**1<sup>st</sup> Further Information**

**Temporary Site office for Permitted Agricultural Use and  
Associated Filling of Land for a Period of 3 Years in “Agriculture” Zone,  
Various Lots in D.D. 110, Kam Tin, Yuen Long, New Territories**

**(S.16 Planning Application No. A/YL-KTN/1185)**

DRAWN BY	DATE
DN	10.12.2025
REVISED BY	DATE
APPROVED BY	DATE
DWG. TITLE	
FSIs PROPOSAL	
DWG. NO.	VER.
APPENDIX I	001

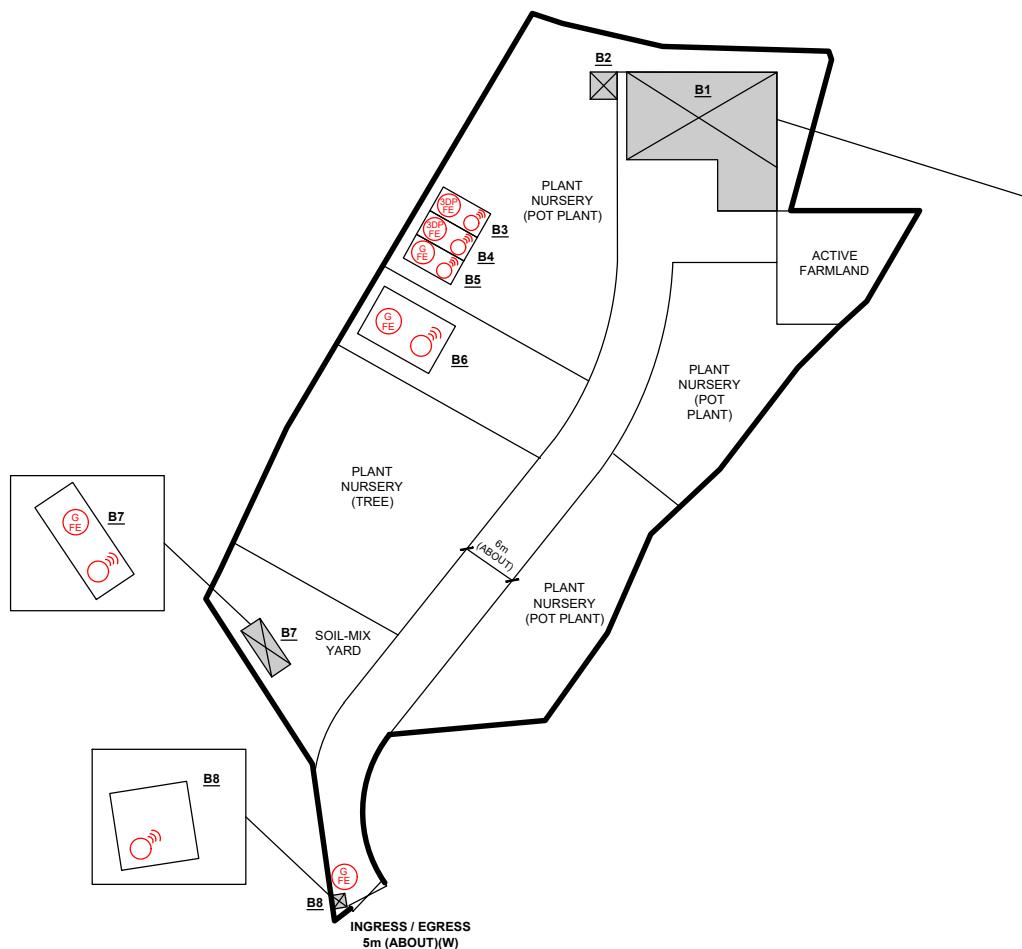
(1)	For enclosed structure with gross floor area not exceeding 230m <sup>2</sup> , only fire extinguisher and Stand-alone Fire Detector shall be provided;	Noted. The revised FSIs proposal is enclosed for your reference please ( <b>Appendix II</b> ).

(2)	In addition to (1) above, where two or more Stand-alone Fire Detectors are installed in an enclosed structure, all stand-alone detectors shall be interconnected (either wired or wirelessly) such that when one of the stand-alone fire detector is triggered, all connected Stand-alone Fire Detectors shall sound an alarm simultaneously;

(3)	The Stand-alone Fire Detector shall be provided in accordance with the "Stand-alone Fire Detector General Guidelines on Purchase, Installation & Maintenance [Sep 2021]"; and

(4)	Emergency lighting, directional and exit signs are considered as self-upgrade and not a mandatory requirement by this Department.	
<b>Comments of the Chief Engineer/Construction, Water Supplies Department (CE/C, WSD)</b> <b>(Contact Person: Mr. FONG, Tel.: 2135 2164)</b>
